Preliminary Drainage Report

Megerdichian Assisted Seniors Center (MASC)

25-ZN-2018

Plan #	_____
Case #	25-ZN-2018, Cycle VX
Q-S #	_____
_____	Accepted
_____	X Correction
GA	12/24/2020
Reviewed By	Date

MASTER GRADING AND DRAINAGE PLAN

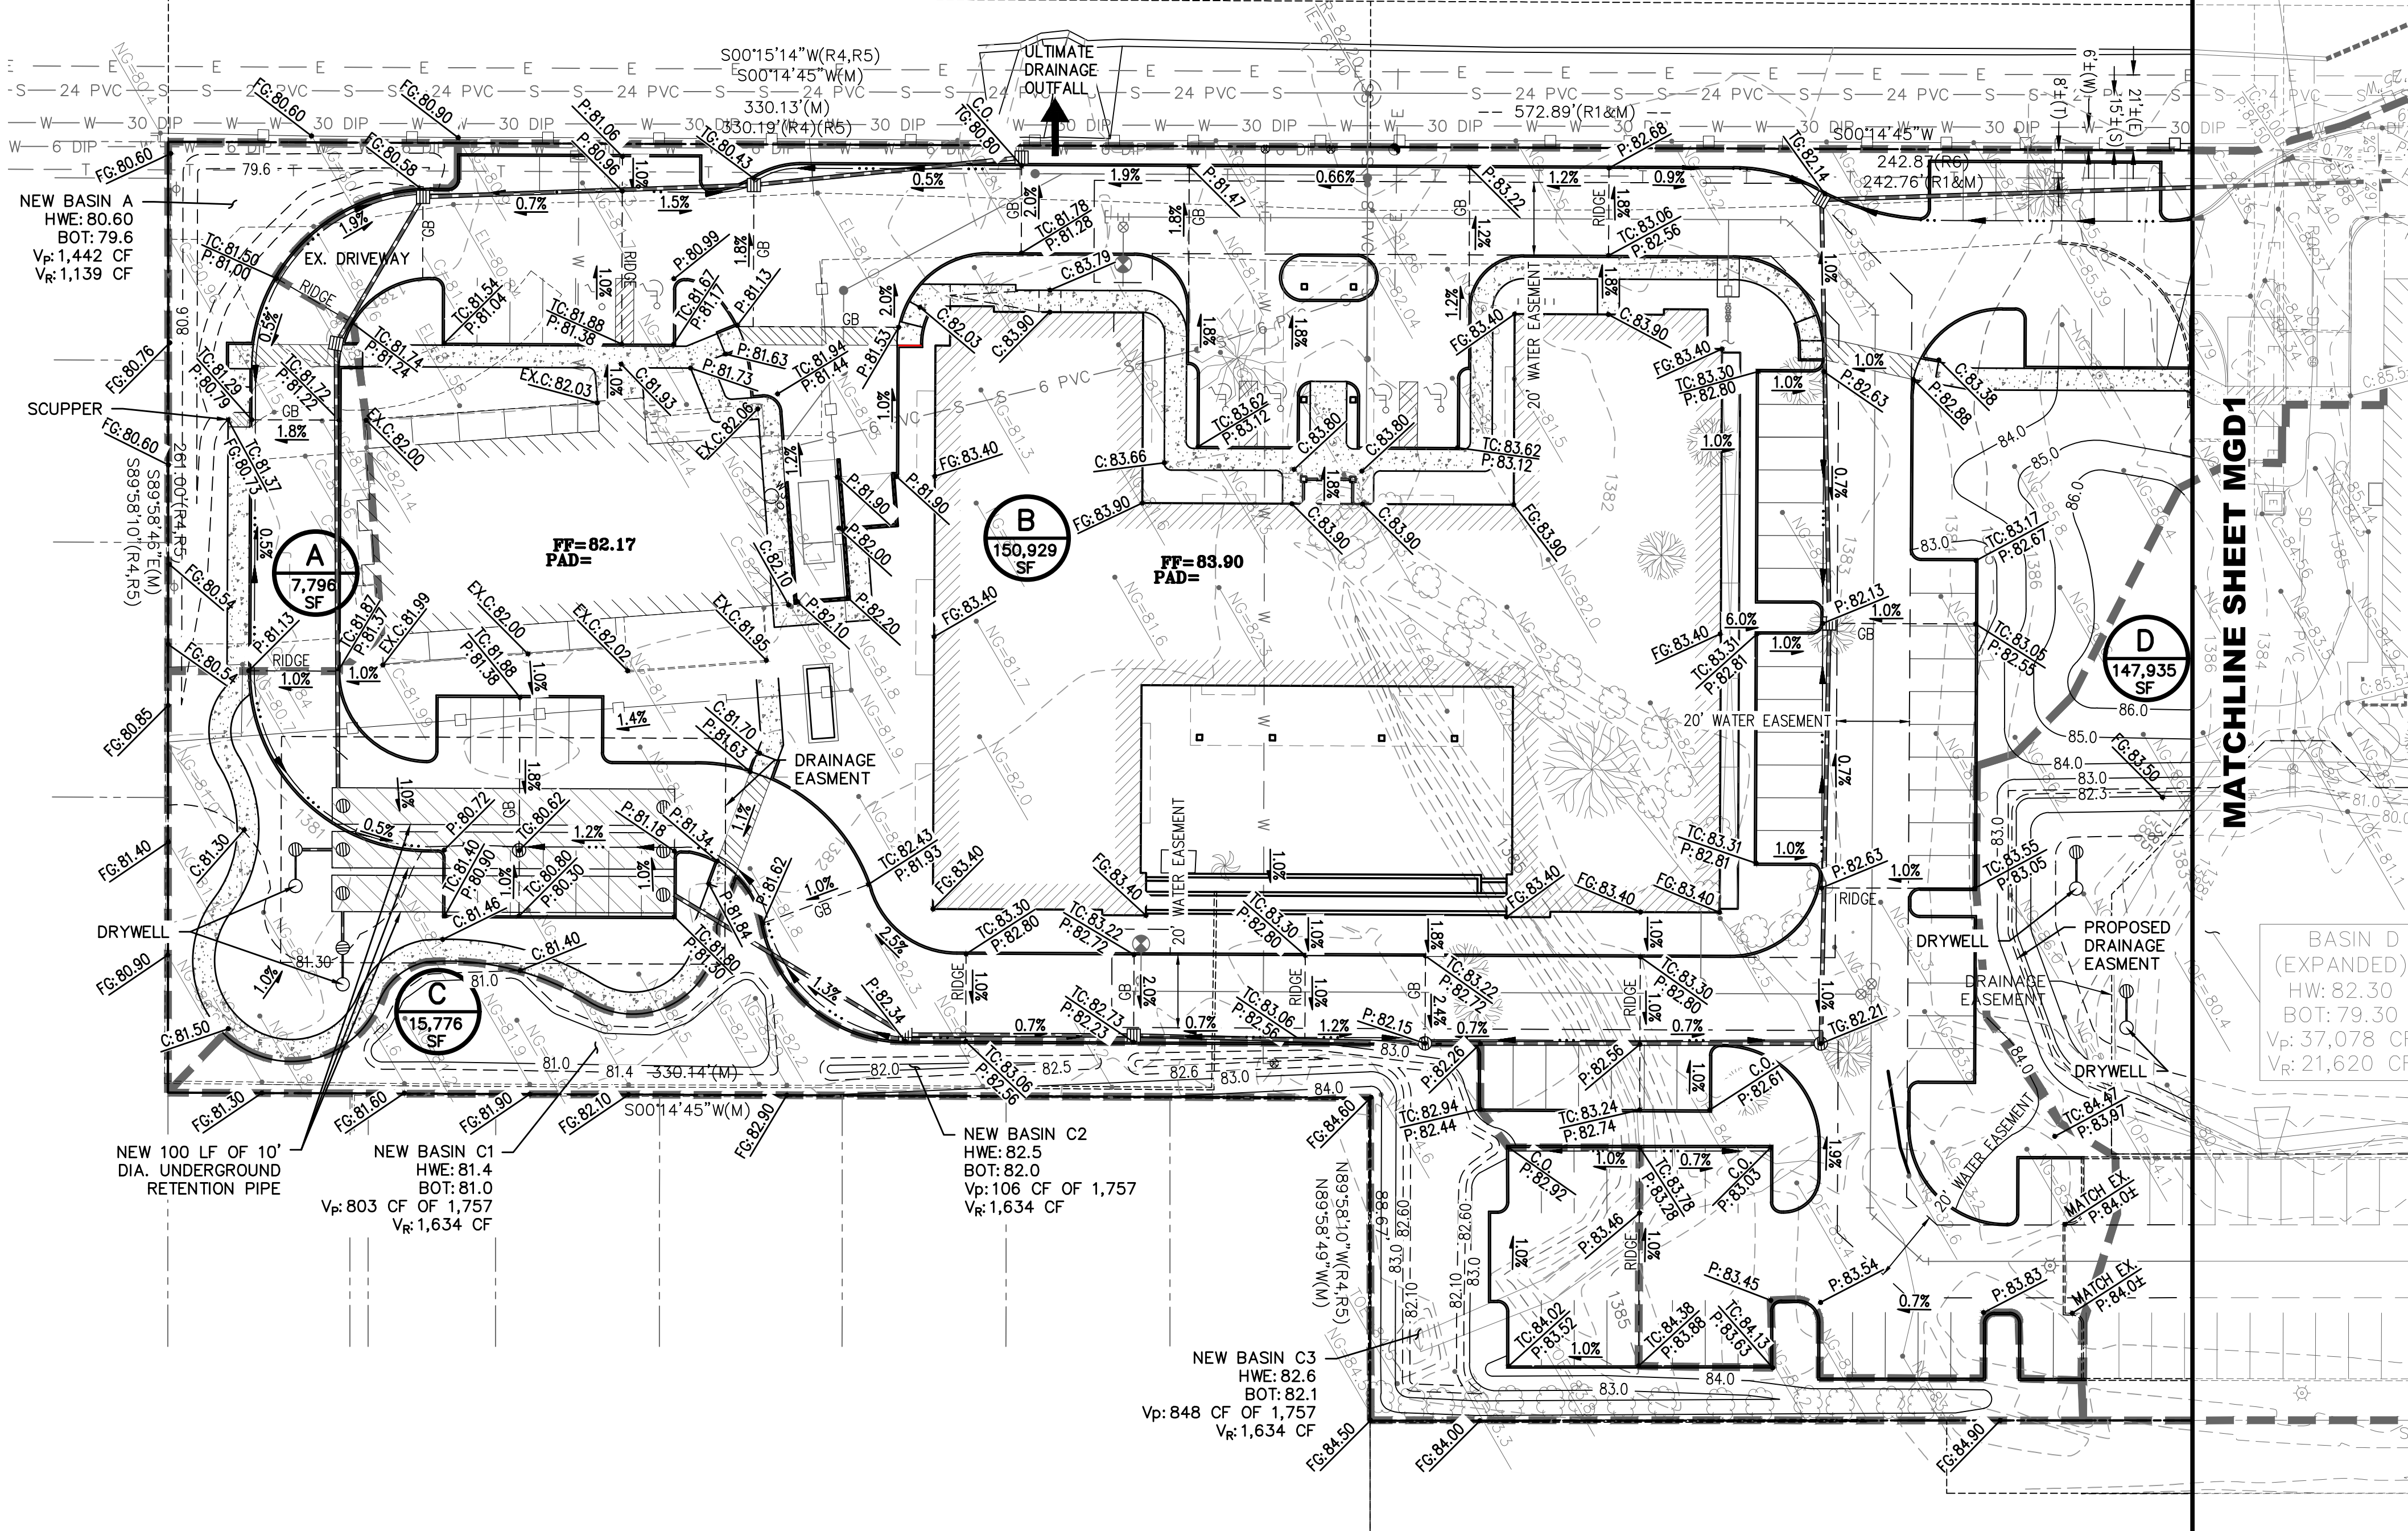
FINAL CONSTRUCTION DOCUMENT NOTES:

1. THE FINAL DRAINAGE REPORT SHOULD NOTE THAT THE PROPOSED UNDERGROUND STORMWATER STORAGE TANKS (USSTS) MUST MEET THE CITY'S USST POLICY IN SECTION 4-1.202 OF THE CITY'S DESIGN STANDARDS & POLICIES MANUAL (DSPM), WHICH INCLUDES BUT IS NOT LIMITED TO THE FOLLOWING:
(PLEASE REVIEW THE REFERENCED SECTION COMPLETELY TO ADDRESS ANY OUTSTANDING APPLICABLE ITEMS. DISCUSS AND INCORPORATE IN THE DRAINAGE REPORT AS APPLICABLE).

- A. THE OWNER MUST DEDICATE A PUBLIC DRAINAGE EASEMENT OVER THE USST, WITH NO MAJOR VEGETATION SUCH AS TREES WITHIN THE EASEMENT. AT A MINIMUM, THE EASEMENT SHOULD EXTEND AT A PROJECTED SLOPE OF 1:1 FROM THE BOTTOM OF THE PIPE.

- B. THE USST MUST HAVE AT LEAST A 75-YEAR LIFE, INCLUDING THE LINING AND COATING.
 - C. THE USST MUST DRAIN BY GRAVITY.
 - D. SPECIFY MAG SUPPLEMENTAL STANDARD DETAIL 2554 FOR CORRUGATED METAL PIPES.

- E. A MINIMUM OF TWO ACCESS POINTS MUST BE PROVIDED FOR EACH USST.
 - F. AN OPERATIONS AND MAINTENANCE (O&M) MANUAL MUST BE PREPARED FOR THE SYSTEM PRIOR TO APPROVAL OF FINAL PLANS.

- G. FINAL PLANS MUST INCLUDE SIGNS AT EACH END OF THE USST.
 - H. A SIGNED AND NOTARIZED OWNERSHIP AND RESPONSIBILITY STATEMENT MUST BE PROVIDED PRIOR TO APPROVAL OF FINAL PLANS.

- I. ADD THE REQUIRED WARNING SIGNS
